# RECORD PLANS

Contractor: DIRT TECH COMPANY, LLC  
 Resident Engineer: GREG WILCOX  
 Construction Began: AUGUST 25, 2017  
 Construction Complete: OCTOBER 23, 2018  
 Record Plans By: TAYLOR WARING & JESSE IVES

## PROPOSED IMPROVEMENT CITY OF SOUTH BURLINGTON COUNTY OF CHITTENDEN I-189 (PRINCIPAL ARTERIAL - INTERSTATE - NHS)

DIRECTOR OF PROJECT DELIVERY	
APPROVED:	DATE 4/19/2017
PROJECT MANAGER :	KEN UPMAL, P. E.
PROJECT NAME :	SOUTH BURLINGTON
PROJECT NUMBER :	IM SCR (21)
SHEET 1 OF 29 SHEETS

PROJECT NAME:	SOUTH BURLINGTON	PLOT DATE:	27-APR-2017
PROJECT NUMBER:	IM SCRP(21)	DRAWN BY:	C. LEACH
FILE NAME:	I6d064/Design/xs.dgn	CHECKED BY:	M. BOOKER
PROJECT LEADER:	K. UPMAL	SHEET	28 OF 30
DESIGNED BY:	C. LEACH		
SLOPE CROSS SECTION SHEET 2

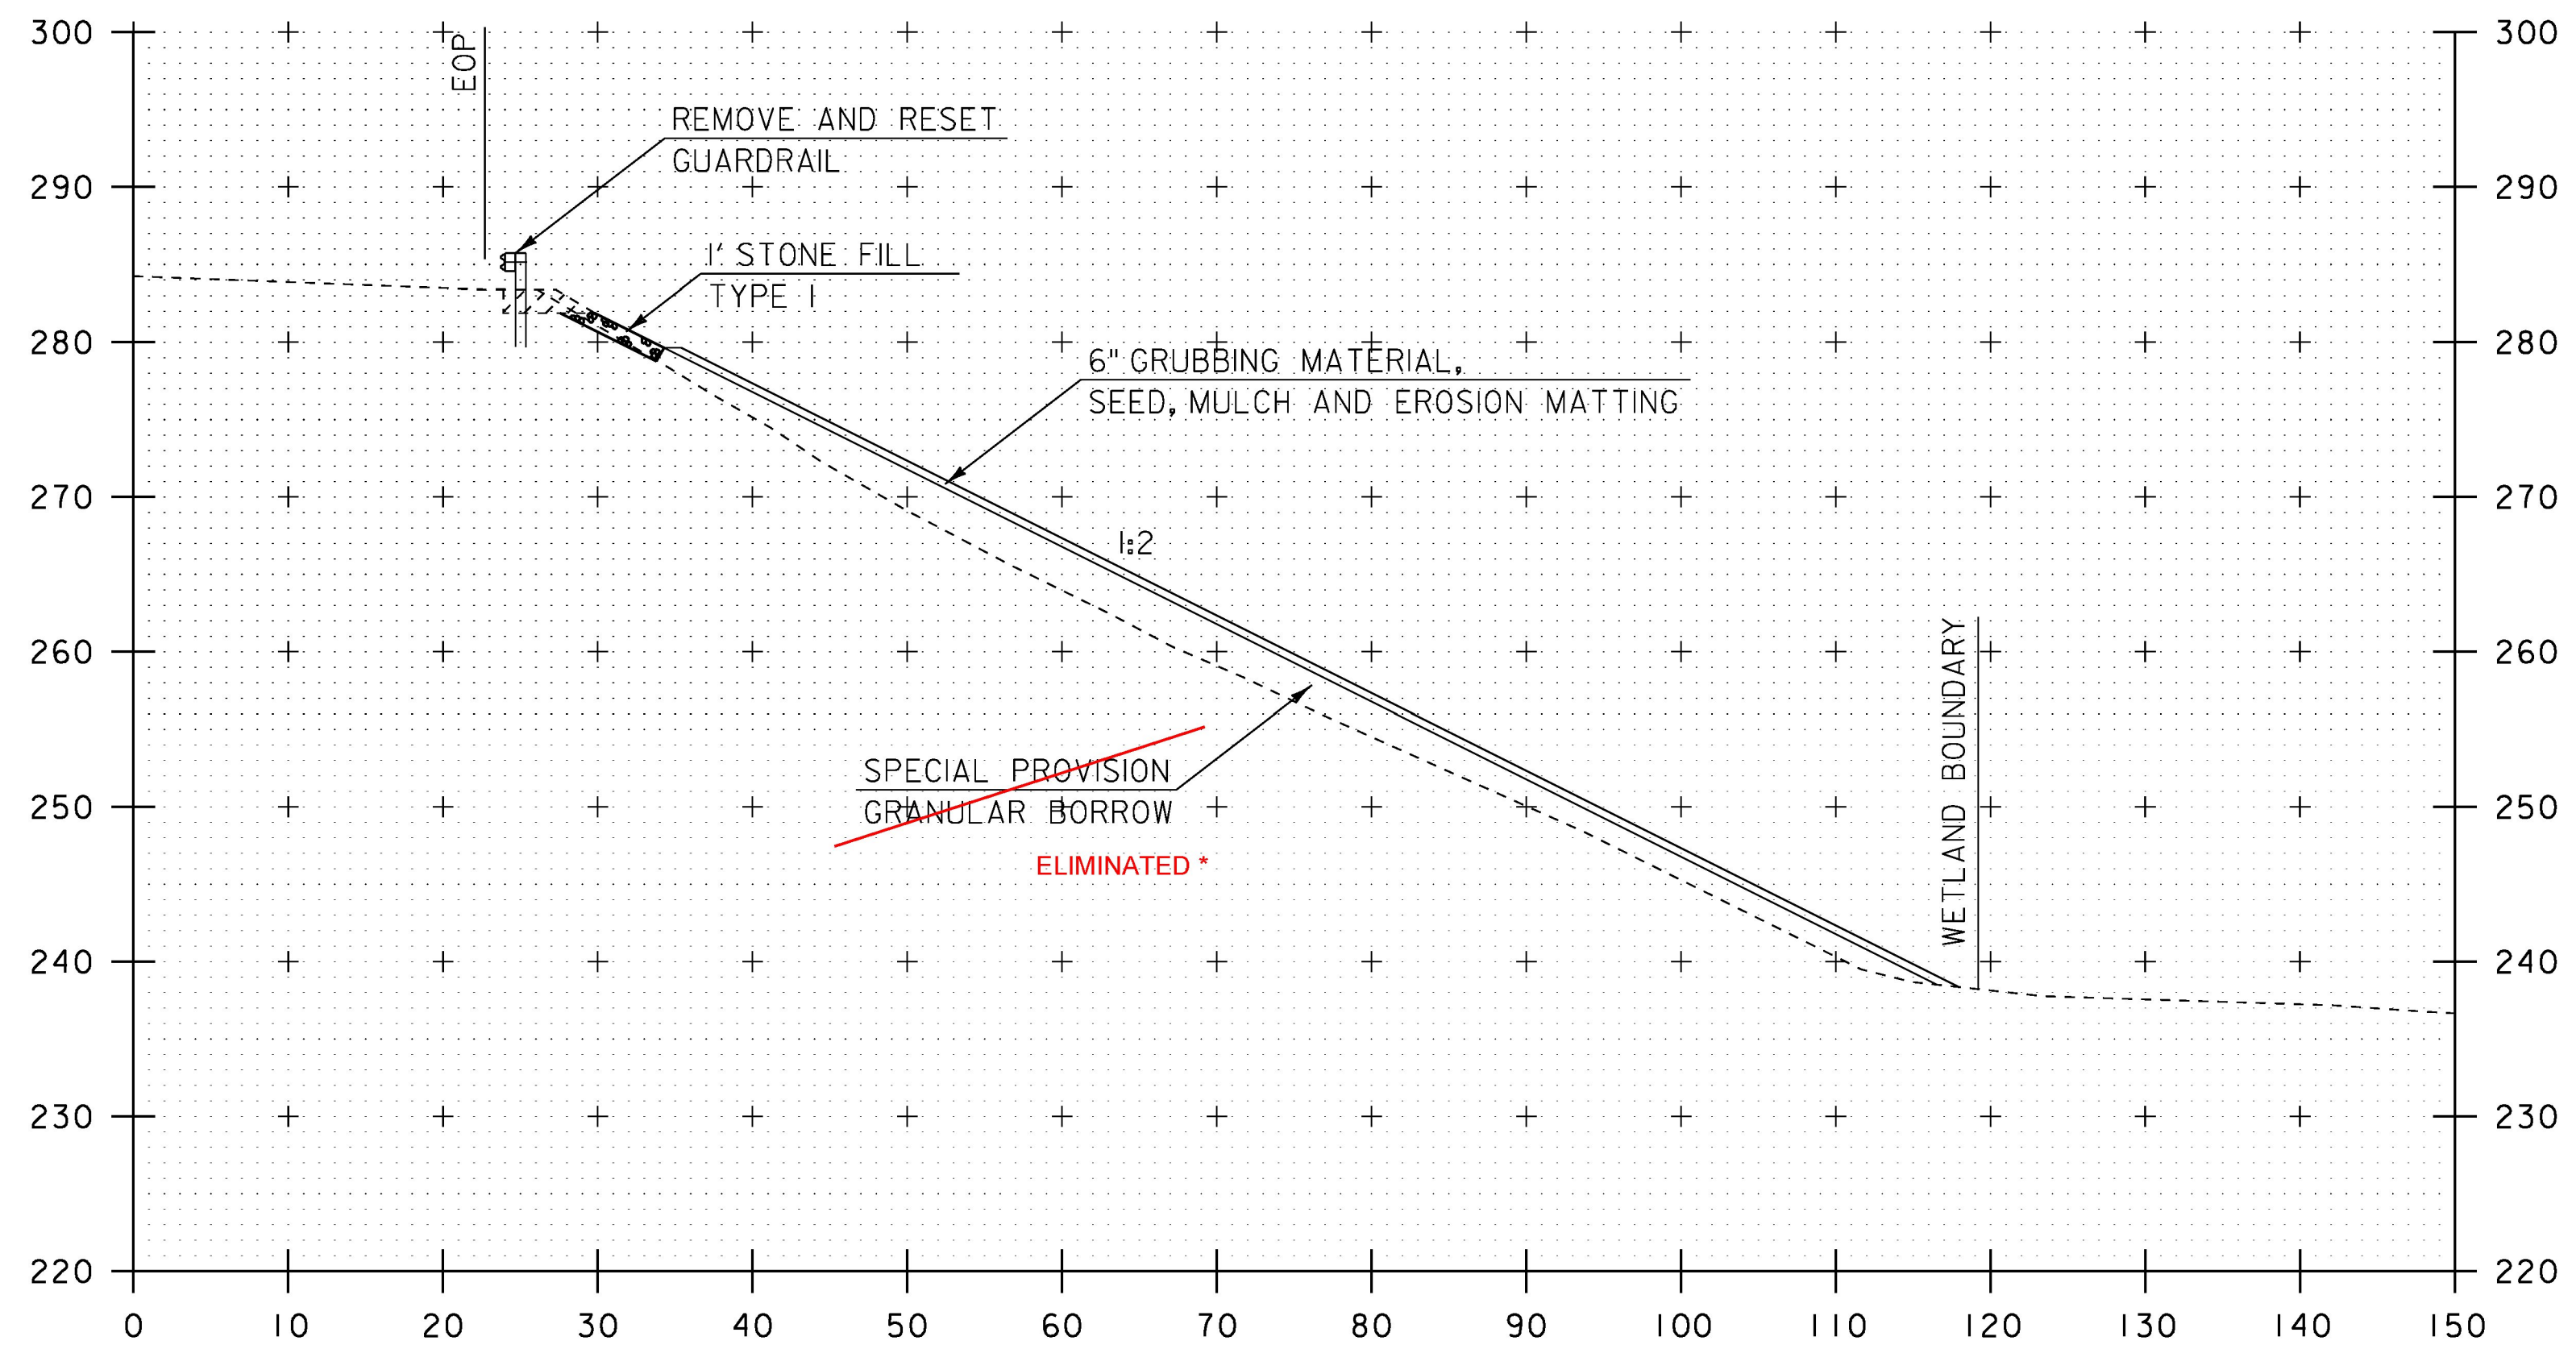
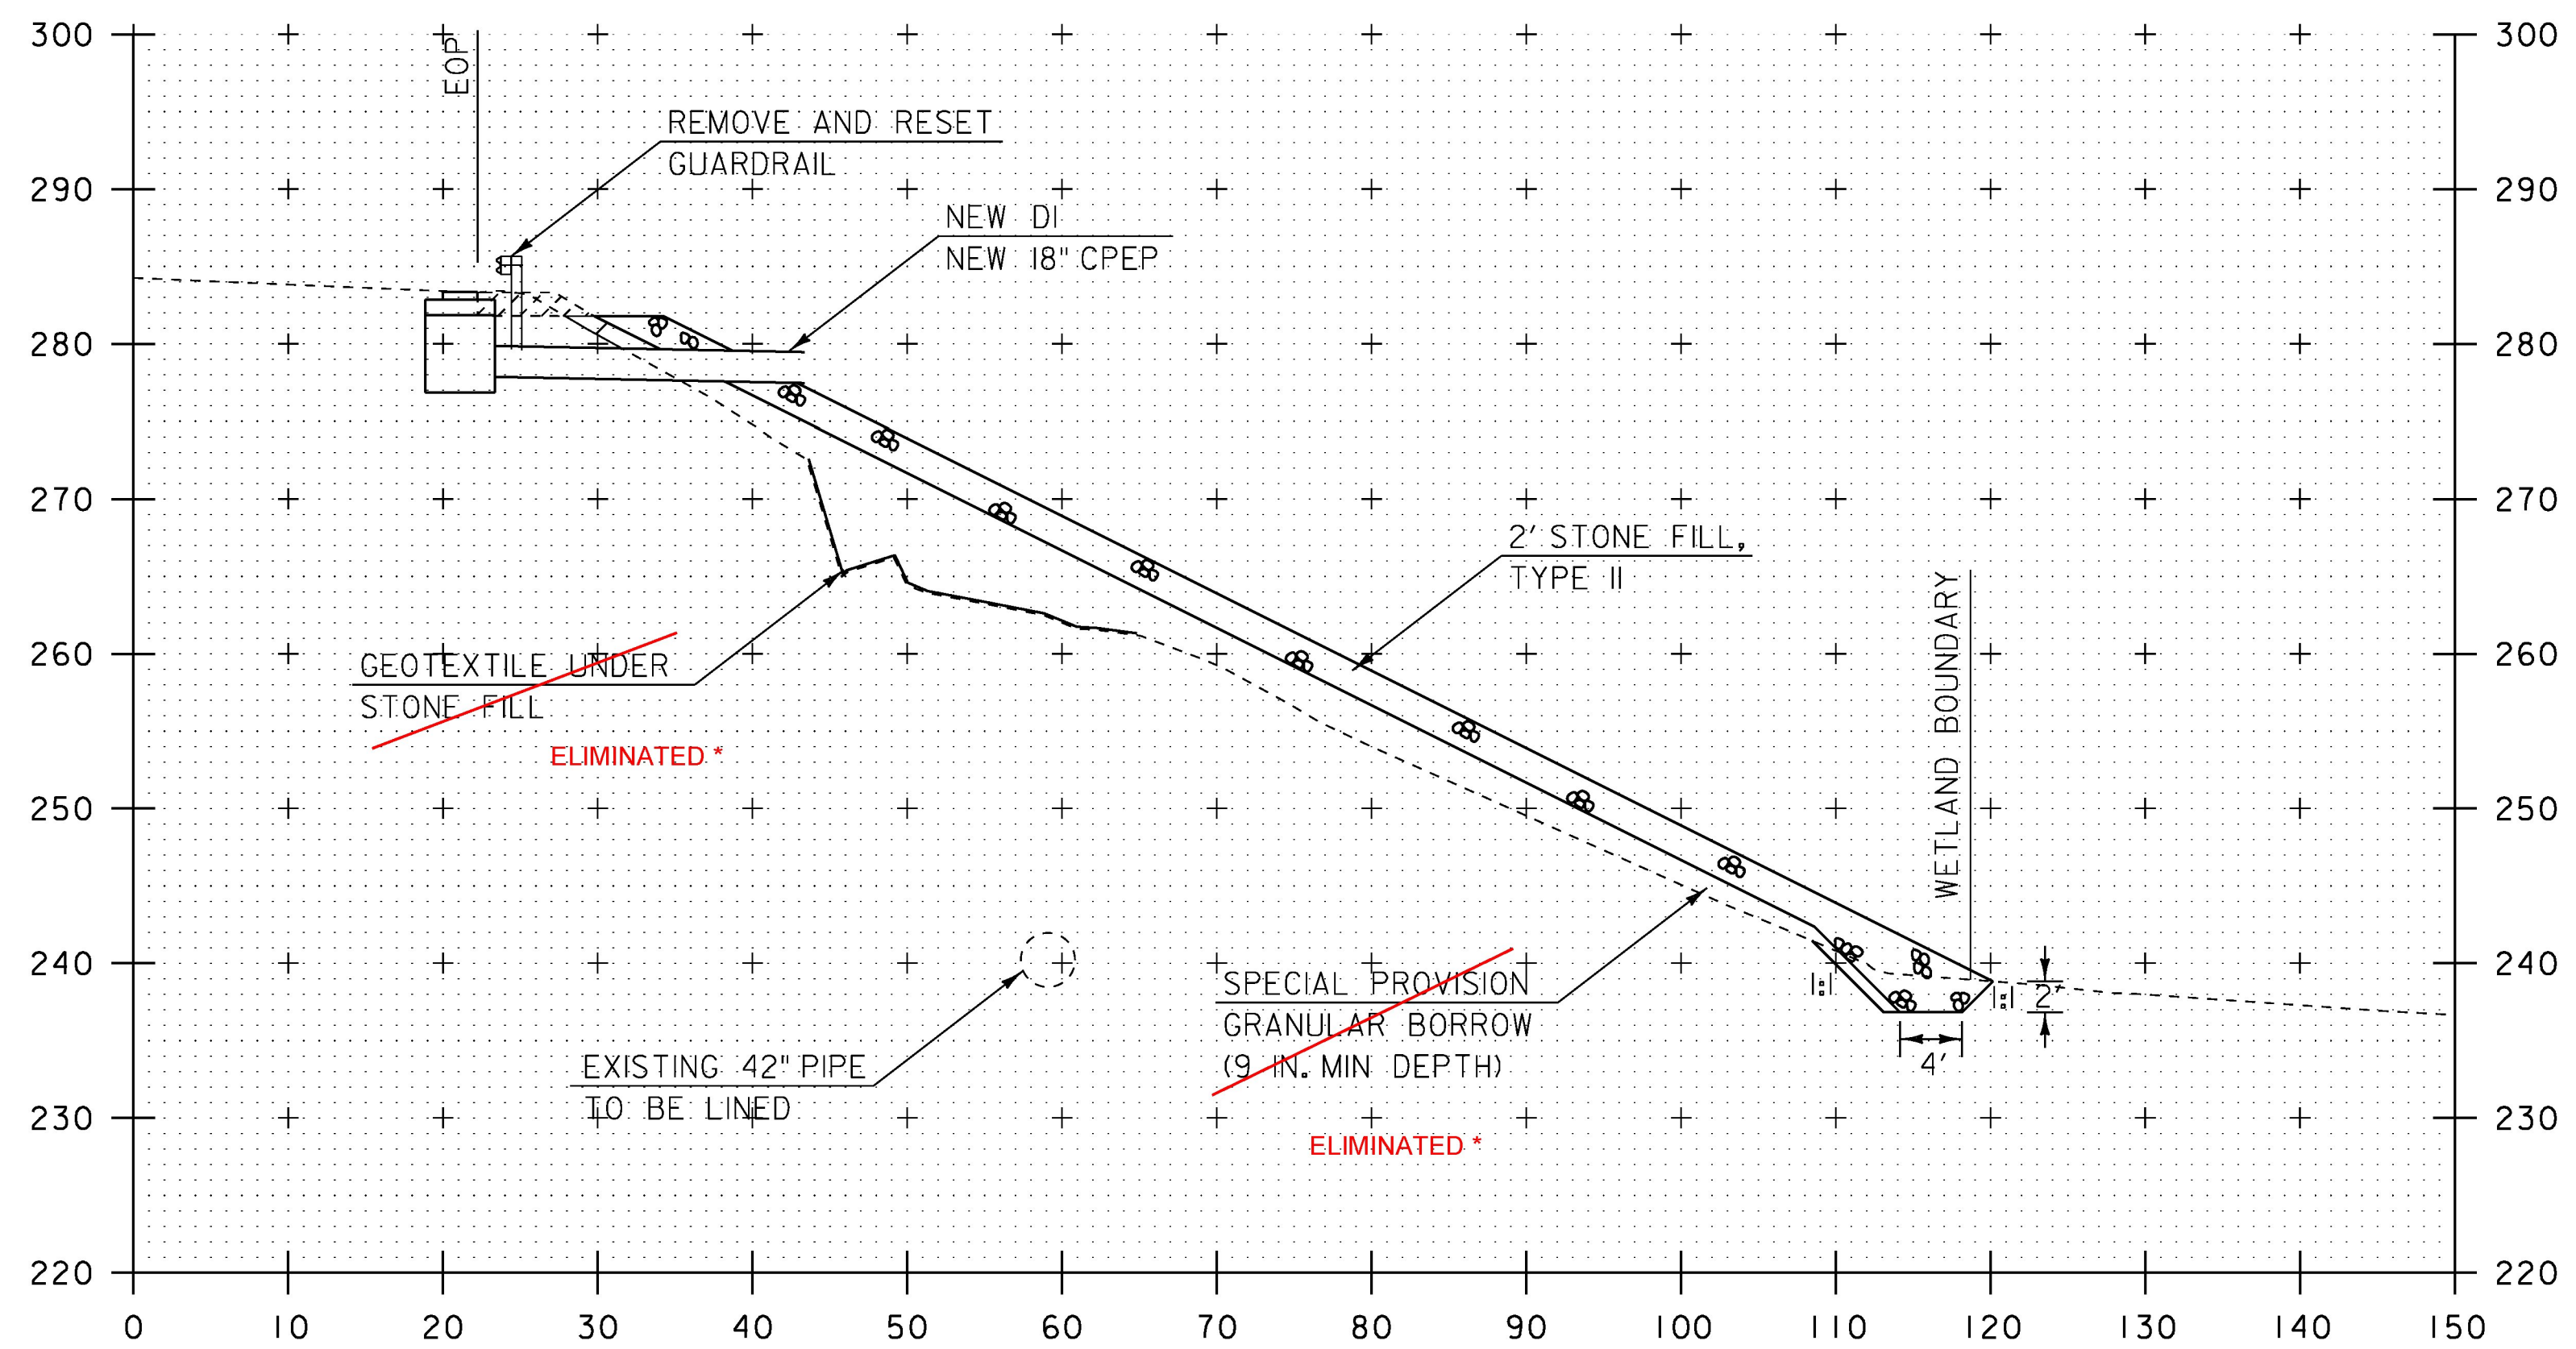
\* SEE NOTE ON PAGE 27
